Subject: License Amendment Application to Increase Allowable Power  
(License Amendment Request No. 00-0006)

Enclosed is an application for an amendment to the Davis-Besse Nuclear Power Station (DBNPS), Unit Number 1 Operating License Number NPF-3, including the Appendix A, Technical Specifications. The proposed changes involve: Operating License (OL) paragraph 2.C(1), Maximum Power Level; OL paragraph 2.C(3)(d), Additional Conditions; Technical Specification (TS) 1.3, Definitions – Rated Thermal Power; TS 2.1.1, Safety Limits – Reactor Core, and associated Bases; TS 2.2.1, Limiting Safety System Settings – Reactor Protection System Setpoints, and associated Bases; TS 3/4.1.1.3, Reactivity Control Systems – Moderator Temperature Coefficient; TS 3/4.2.5, Power Distribution Limits – DNB Parameters; TS 3/4.4.9.1, Reactor Coolant System – Pressure/Temperature Limits, and associated Bases; and TS 6.9.1.7, Core Operating Limits Report.

Proposed Modifications to the Davis-Besse Nuclear Power Station (DBNPS) Unit Number 1, Facility Operating License NPF-3, Including the Appendix A Technical Specifications, to Allow a Power Uprate and to Revise Departure From Nucleate Boiling Parameters.

Figure 2.1-1 Reactor Core Safety Limit

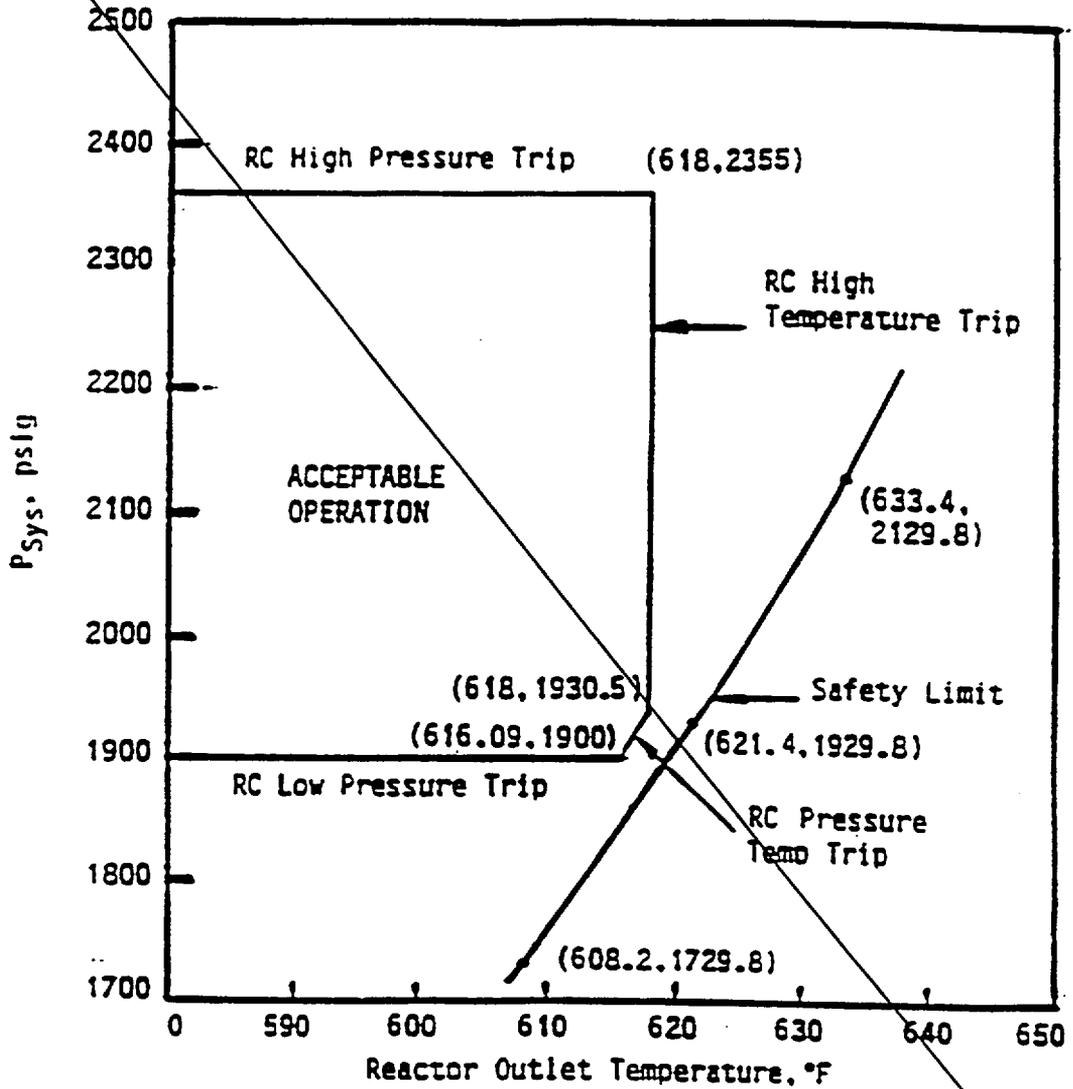
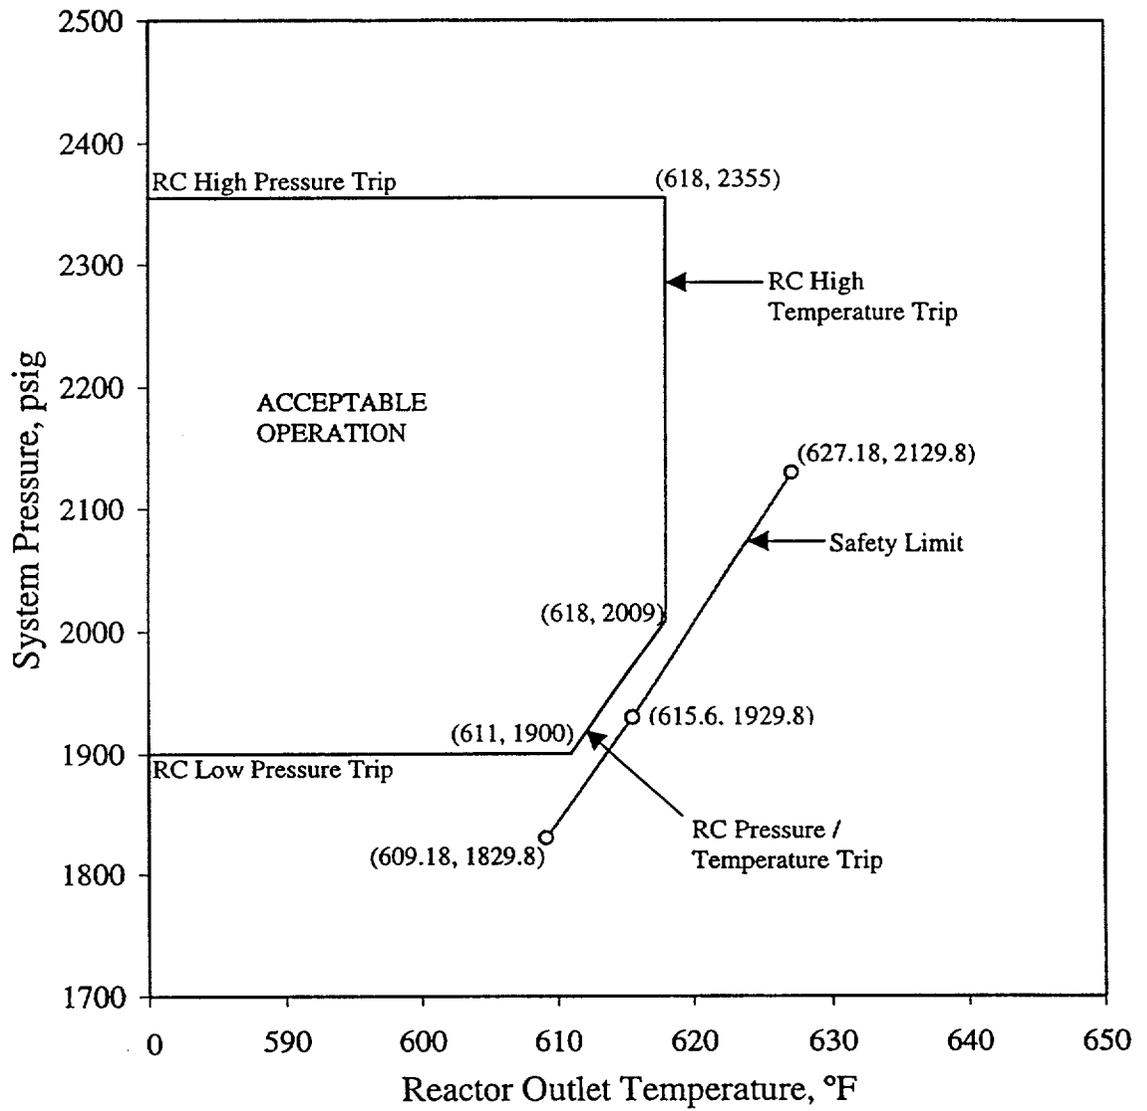
TS 2.1.1 states that the combination of reactor coolant outlet pressure and outlet temperature shall not exceed the safety limit shown in Figure 2.1-1, Reactor Core Safety Limit. It is proposed to revise Figure 2.1-1 to reflect updated data as a result of the proposed power uprate. Related changes to the associated TS Bases are also proposed, including a revised Bases Figure 2.1, Pressure/Temperature Limits at Maximum Allowable Power for Minimum DNBR.

The proposed revision to TS Figure 2.1-1 is in accordance with updated analyses in support of the proposed power uprate, as described in Reference 3. These analyses showed that more restrictive reactor core safety limits were appropriate. Based on the Reference 3 evaluation, this proposed change will have no adverse effect on nuclear safety.

Replace with  
new figure  
(next page)

The curve presented in Figure 2.1-1 represents the conditions at which a minimum DNBR equal to or greater than the correlation limit is predicted for the maximum possible thermal power of 110.2% of 2817 MWt +12% when the reactor coolant flow is 380,000 GPM, which is approximately 108% of design flow rate for four operating reactor coolant pumps. (The minimum required measured flow is 389,500 GPM). This curve is based on the design hot channel factors with potential fuel densification and fuel rod bowing effects.

Bases Figure 2.1 Pressure/Temperature Limits at Maximum Allowable Power for Minimum DNBR

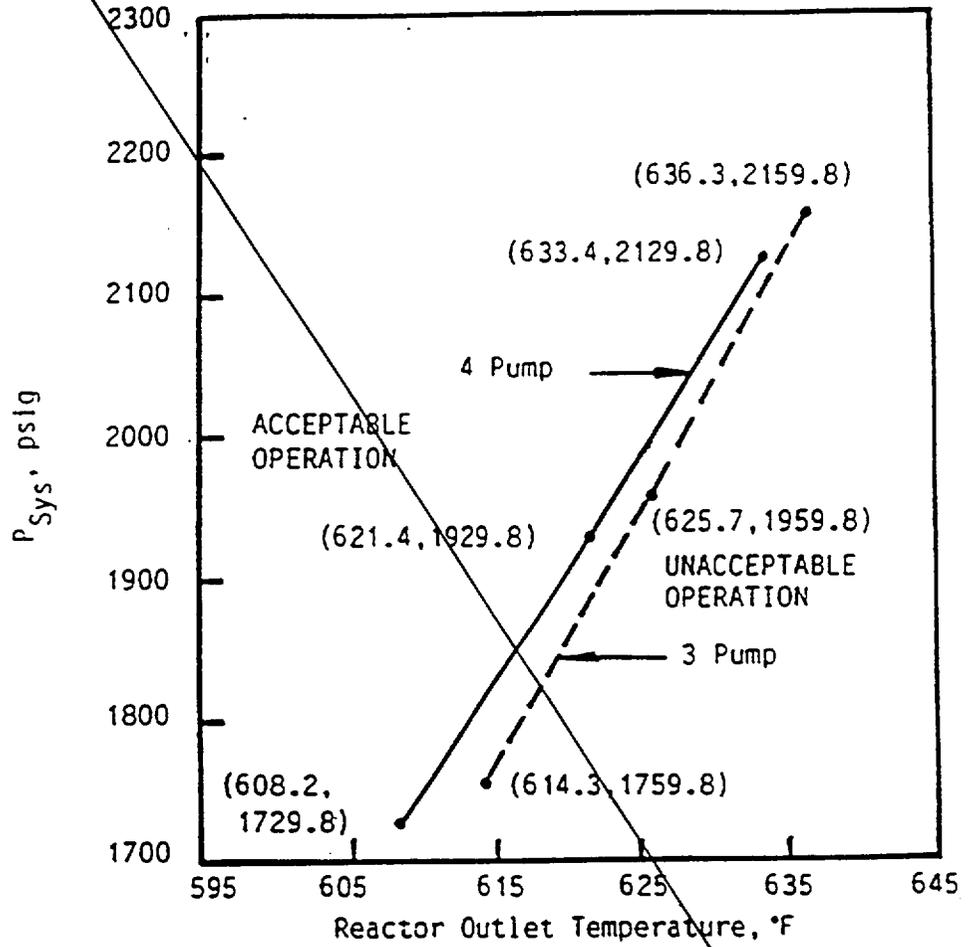
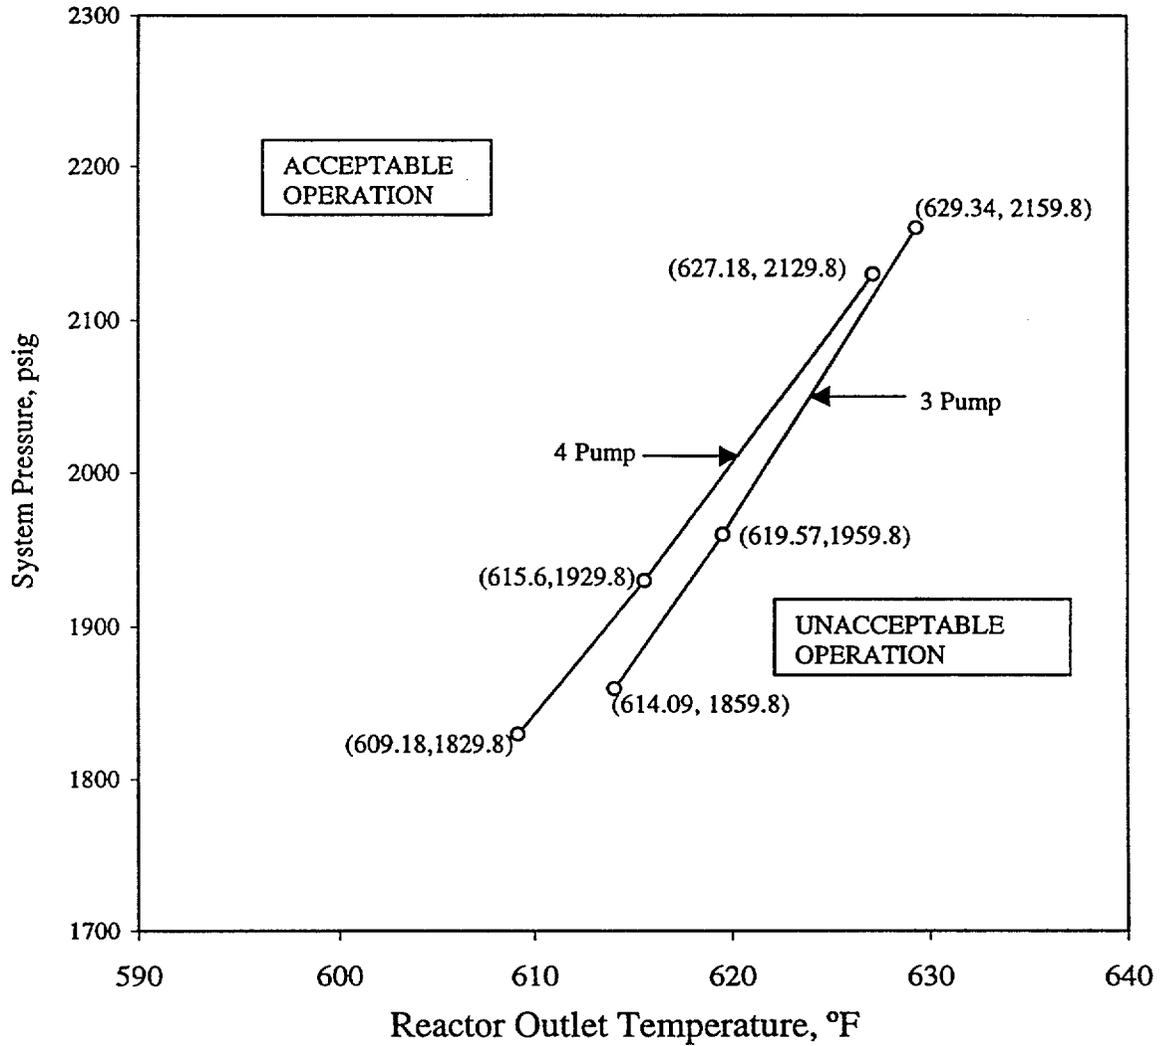
The proposed changes to the associated TS Bases, including a revised Bases Figure 2.1 are related to the above changes, and, as such, are administrative changes that will have no adverse effect on nuclear safety. These changes are supported by the reviews and evaluations described in Reference 3, and reflect the use of the Framatome ANP evaluation method for Statistical Core Design, BAW-10187P-A (Reference 8), that is the basis for the power uprate program DNBR safety evaluations.

*Replace with new Figure (next page)*

The curve of Figure 2.1-1 is the most restrictive of all possible reactor coolant pump-maximum thermal power combinations shown in BASES Figure 2.1. The curves of BASES Figure 2.1 represent the conditions at which a minimum DNBR equal to the DNBR limit is predicted at the maximum possible thermal power for the number of reactor coolant pumps in operation or the local quality at the point of minimum DNBR is equal to the corresponding DNB correlation quality limit (+22% (B&W-2) or +26% (BWC)), whichever condition is more restrictive.

For the curve of BASES Figure 2.1, a pressure-temperature point above and to the left of the curve would result in a DNBR greater than the Statistical Design Limit (SDL) of 1.313 (BWC) ~~1.30 (B&W-2) or 1.18 (BWC)~~ and a local quality at the point of minimum DNBR less than +22% (B&W-2) or +26% (BWC) for that particular reactor coolant pump situation. The DNBR curve for three pump operation is less restrictive than the four pump curve.

Reactor Coolant System Pressure-Temperature Limits  
For Heatup and Core Criticality for the First ~~20~~ 21 EFY

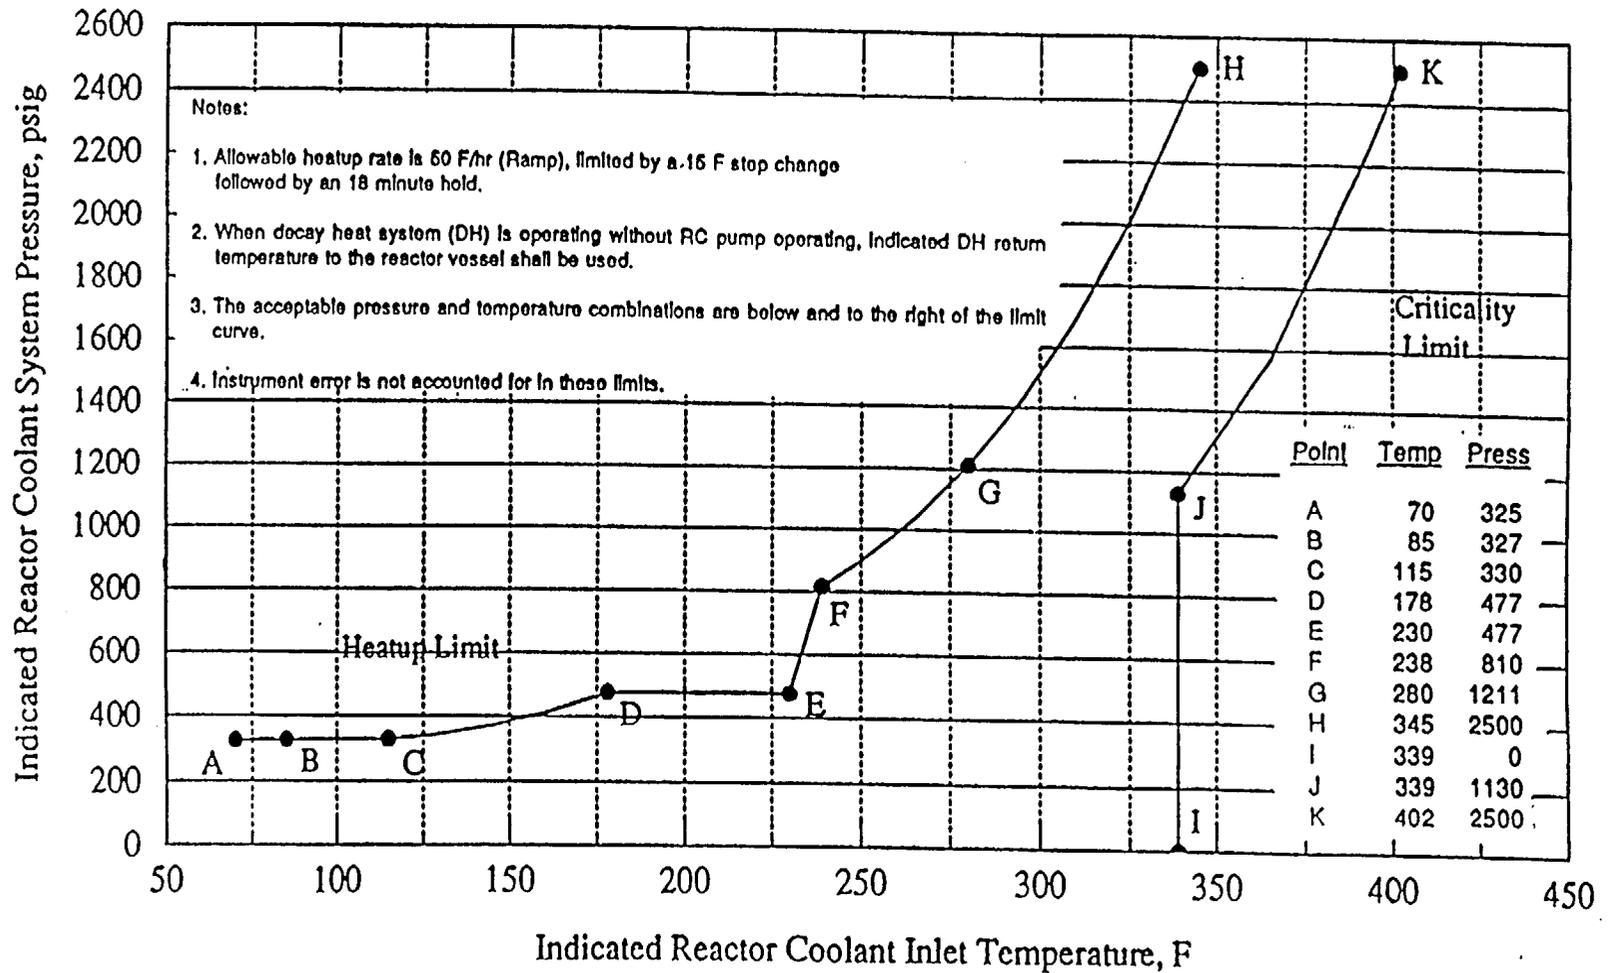
The titles of TS Figures 3.4-2, 3.4-3, and 3.4-4 presently state that they apply for the first 21 Effective Full Power Years (EFPY) of operation. As a result of the proposed power uprate, it is proposed to revise the titles to reflect that these figures now apply to the first 20 EFPY of operation.

The proposed revisions to the titles of TS Figures 3.4-2, 3.4-3, and 3.4-4 is in accordance with updated analyses in support of the proposed power uprate, as described in Reference 3. These analyses showed that due to the power uprate, the pressure/temperature limit curves shown in the figures are now only applicable to the first 20 Effective Full Power Years (EFPY) of operation, rather than the current 21 EFPY. This change continues to ensure that the Reactor Coolant System pressure/temperature limits will be appropriately maintained and, accordingly, this change will have no adverse effect on nuclear safety.
